## Permitting decisions - Refusal

We have decided to refuse the permit application for United Utilities Burnley Wastewater Treatment Works Sludge Treatment Facility operated by United Utilities Water Limited, application number EPR/HP3509MM/A001 (the Application)

The proposed facility location is Burnley Wastewater Treatment Works Sludge Treatment Facility, Woodend Lane, Off Barden Lane, Burnley, BB12 9DS indicatively shown edged in green on the plan attached at Annex 3 (the Site).

**Figure 2 – Site Surfacing Plan**

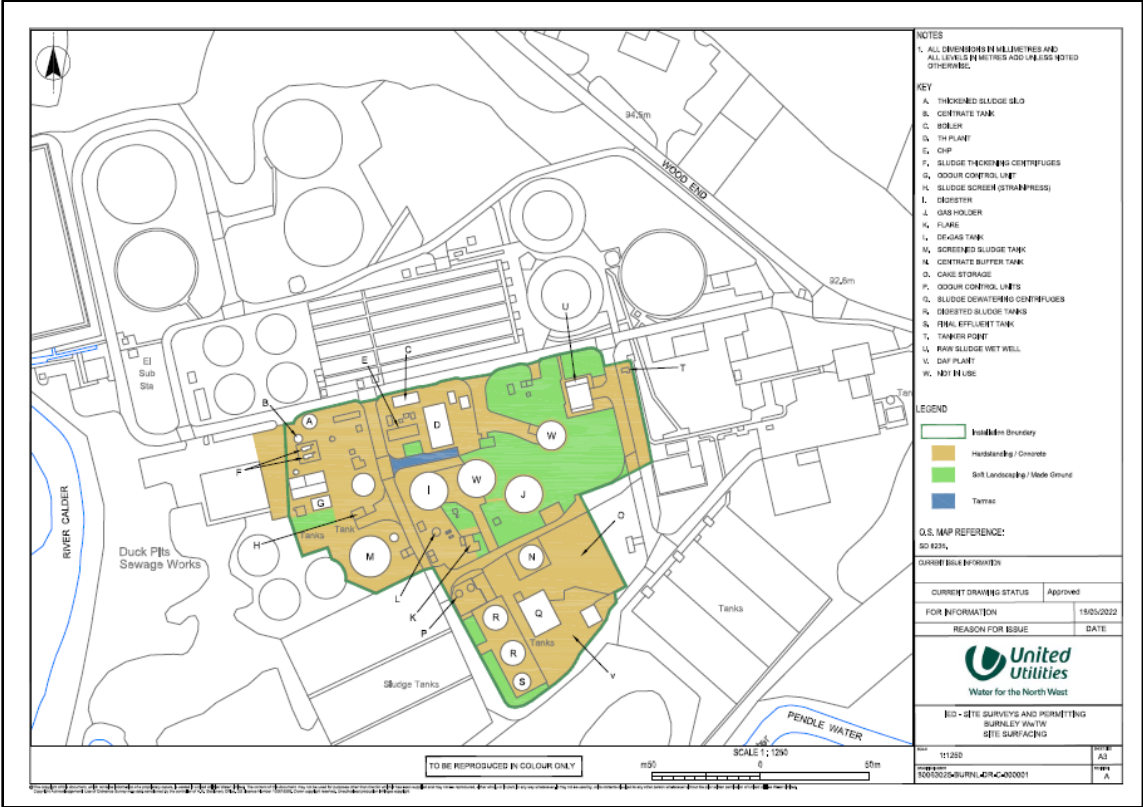
Impermeable surfacing is required in operational areas to prevent soil and water contamination. The Applicant stated in their Application Support Document dated June 2021 that “The majority of the installation area is hard surfaced so that it is impermeable. However, as is common on such sites there are also some gravelled areas which are more vulnerable to spillages”. The Site surfacing plan identified

areas within the proposed permitted boundary that are “Hardstanding / concrete”, “Soft Landscaping / made ground” or “Tarmac” which were not identified as impermeable.

We disagree that the factors outlined above would provide an equivalent level of environmental protection to the provision of impermeable surfacing as outlined in BAT Conclusion 19c (provision of impermeable surfacing). Information provided was vague and did not demonstrate how the proposals would mitigate any impact in the event of catastrophic failure. In particular, while the Applicant proposed the use of a fleet of sludge tankers, it was not clear how this would minimise any environmental impact, no firm procedures for these emergency tankers and no further details were provided in relation to the maintenance plans proposed to minimise the risk of tank failure.

It will be noted that the Applicant advised that large amounts of concrete would incur high capital cost and impact the Applicant's aim of achieving net zero. However, the Applicant did not provide any evidence of, or otherwise demonstrate the carbon impact, or consider alternatives to the use of concrete for impermeable surfacing. Unless the applicability criteria states otherwise, the BAT is usually considered to be affordable across the industry sector as a whole for both newly built plant and a "typical" existing plant. A cost benefit analysis in relation to impermeable surfacing would not be appropriate in relation to the Application as it is only relevant in cases which may qualify for a derogation (or deviation) from BAT, Associated Emission Levels (AEL). In any event cost alone is not a valid reason for seeking a deviation from BAT AELs and so is of even less relevance to other aspects of BAT. The Applicant specified the site geology as a potential factor in not providing impermeable surfacing but did not carry out a risk assessment to demonstrate that the impact of any spillage would be within the relevant environmental standards, or in concentrations that are the same as the natural background levels in the groundwater. As such no evidence was provided to support the Applicant submission that this should be considered as a factor in providing at least equivalent environmental protection to an impermeable surfacing in line with BAT Conclusion 19c.

### Figure 4 – Group 2 – Screened Sludge Tank

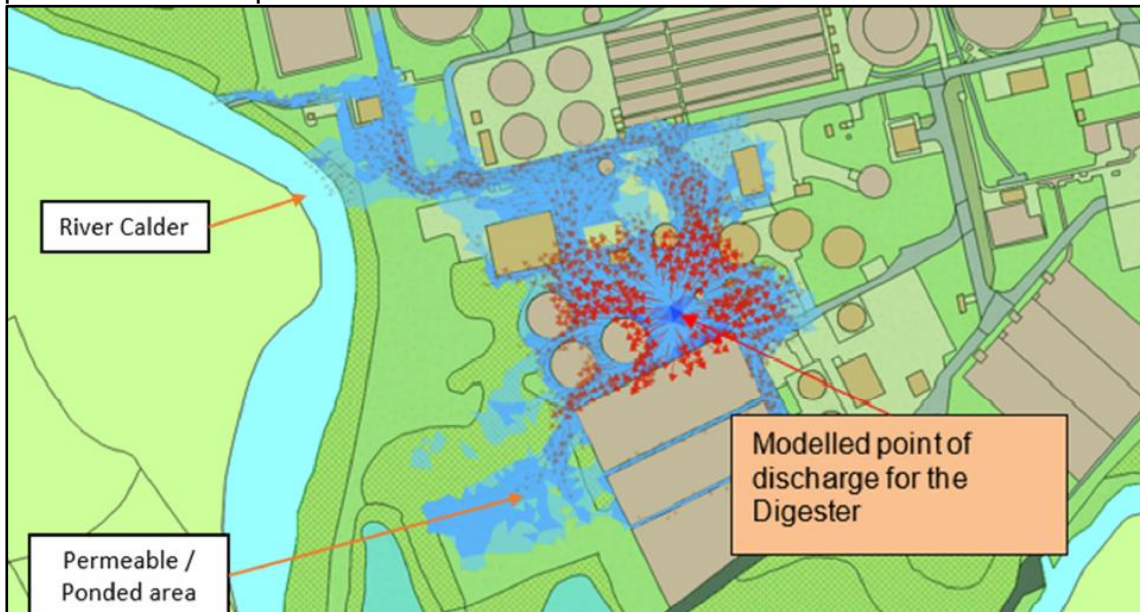
The results of this simulation show in the event of a catastrophic failure that the flow from the screened sludge tank reaches the River Calder and permeable / ponded area receptors.

### Figure 5 – Group 3 – Digested Sludge Tank

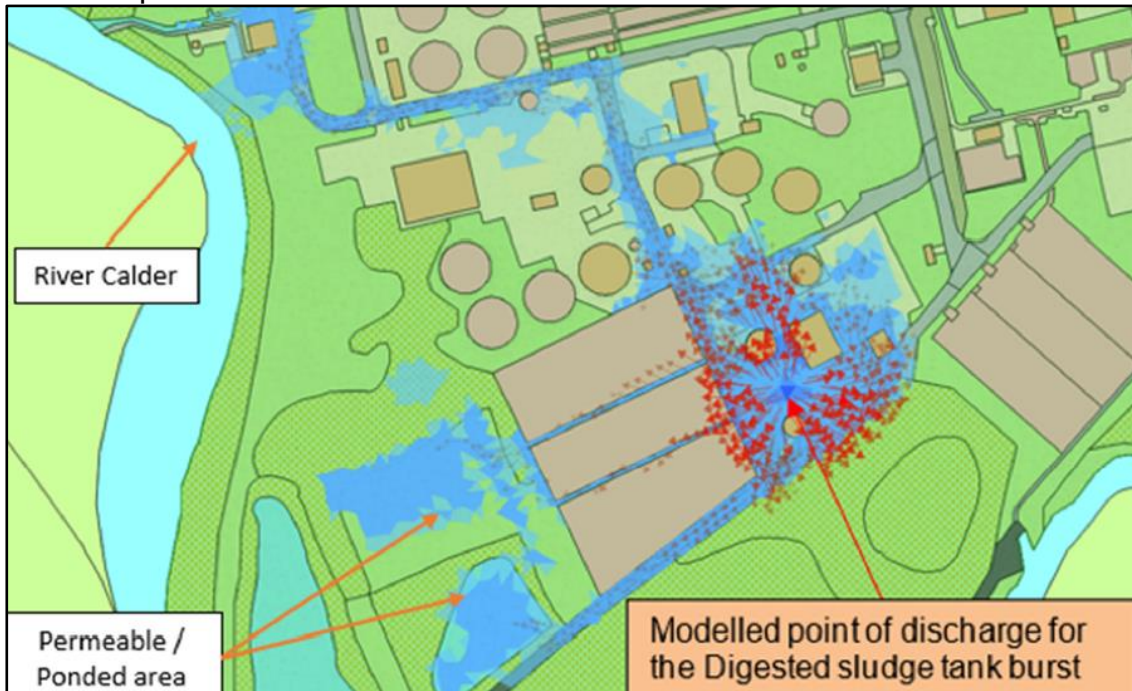
The results of this simulation show a catastrophic failure would result in the flow from the digested sludge tank reaching the River Calder and permeable / ponded area receptors.

### Figure 6 – Group 4 – Thickened Sludge Silo

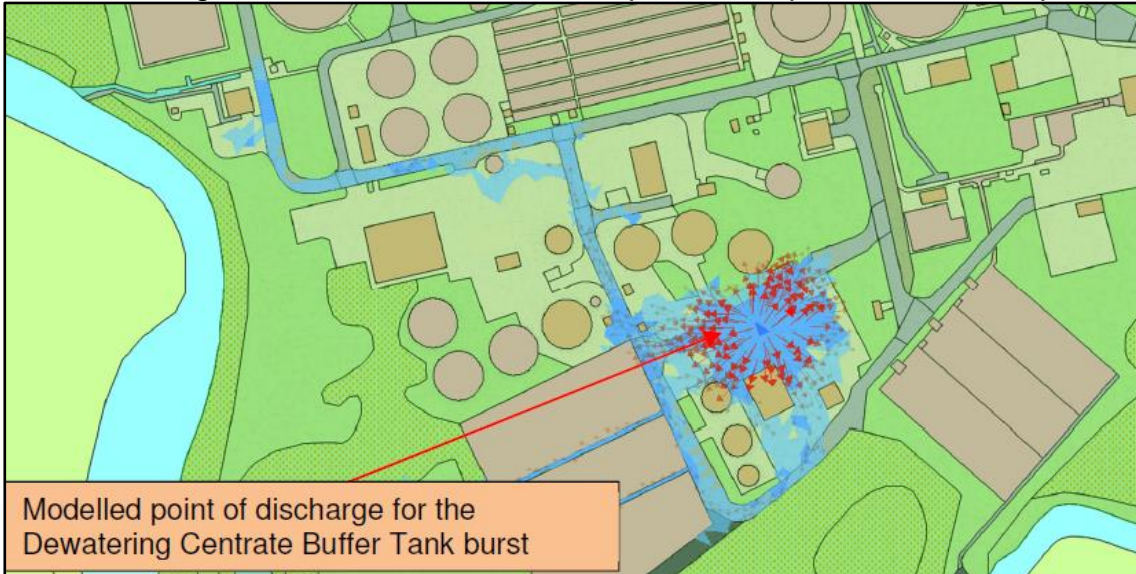
The results from the simulation show that in the event of a catastrophic failure flow from the thickened sludge silo tank reaches the River Calder and permeable/ponded area receptors.

### Figure 8 – Group 6 – Thickening Storage Tank

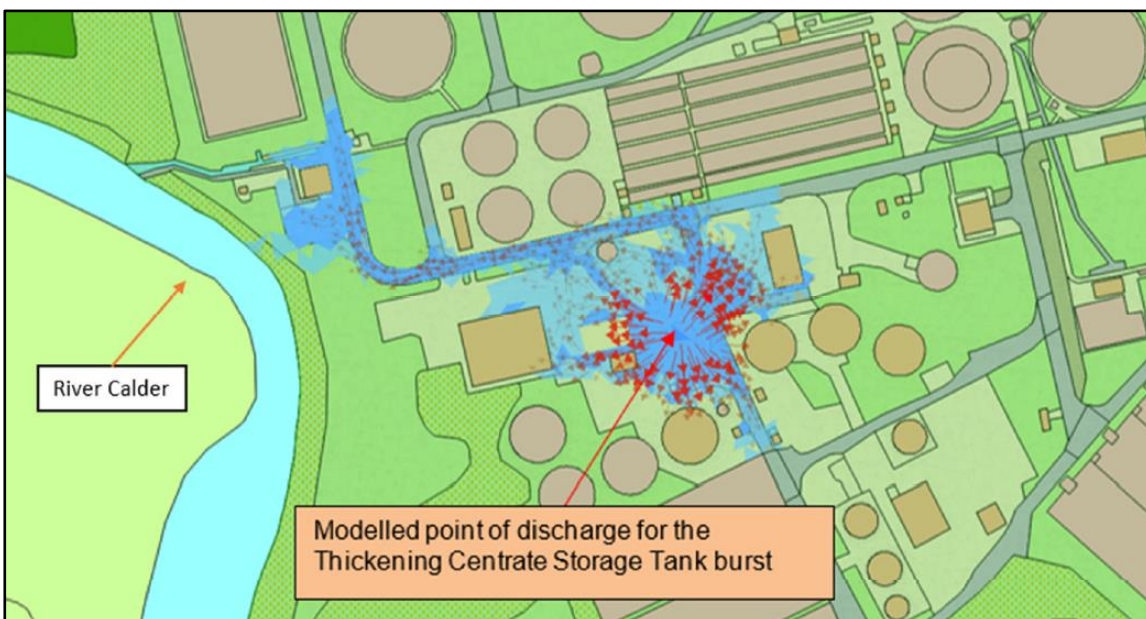
The results from the simulation show that in the event of a catastrophic failure flow from the thickening centrate storage tank reaches permeable/ponded area receptors and the River Calder receptor.

**Figure 9 – Applicants proposed containment solution**

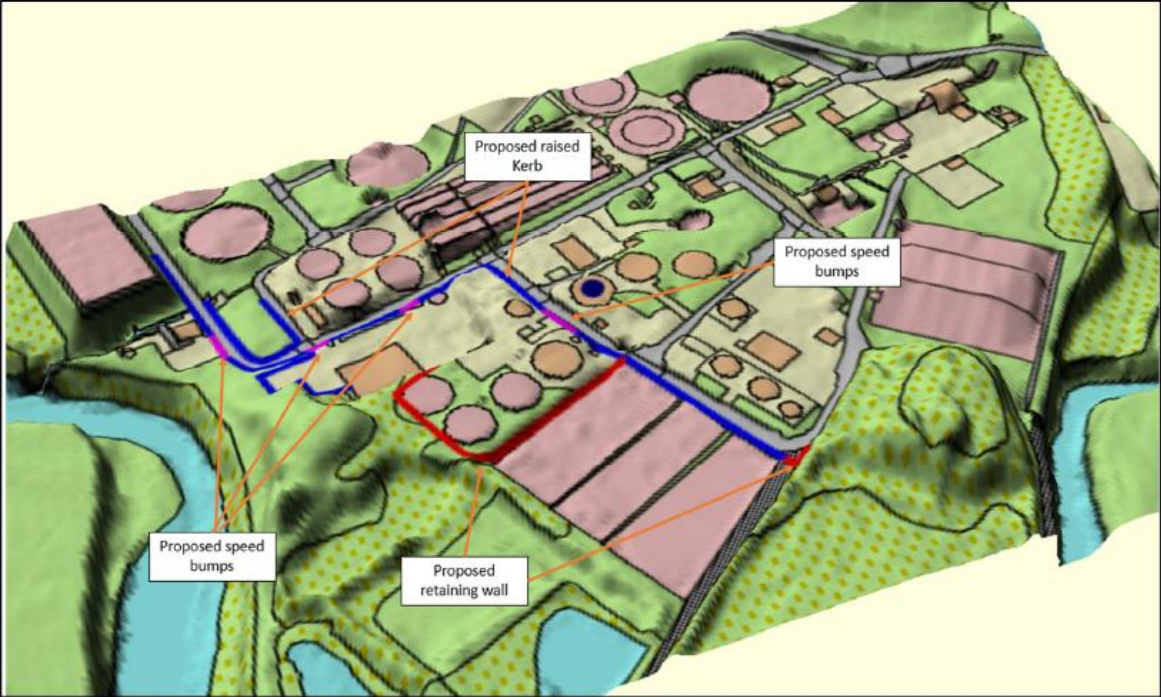
On assessment of this solution the “*proposed pre-cast concrete retaining wall*” (identified as a red line on figure 9 above), would have contained a spill within areas identified in the site surfacing as “Soft Landscaping / Made ground” which have not been identified as impermeable surfaces. No calculations were provided to demonstrate that the solutions proposed would allow for the containment of 110% of the largest tank, or 25% of the total volume of the tanks, and no spill modelling

The proposals lack the detail required for us to adequately assess improvements, they do not explain or provide information on existing containment in place, they do not address failures in tanks included and not included in the spill modelling, and they have not been run through the spill modelling to show the impact following implementation or installation of the solutions/improvements.
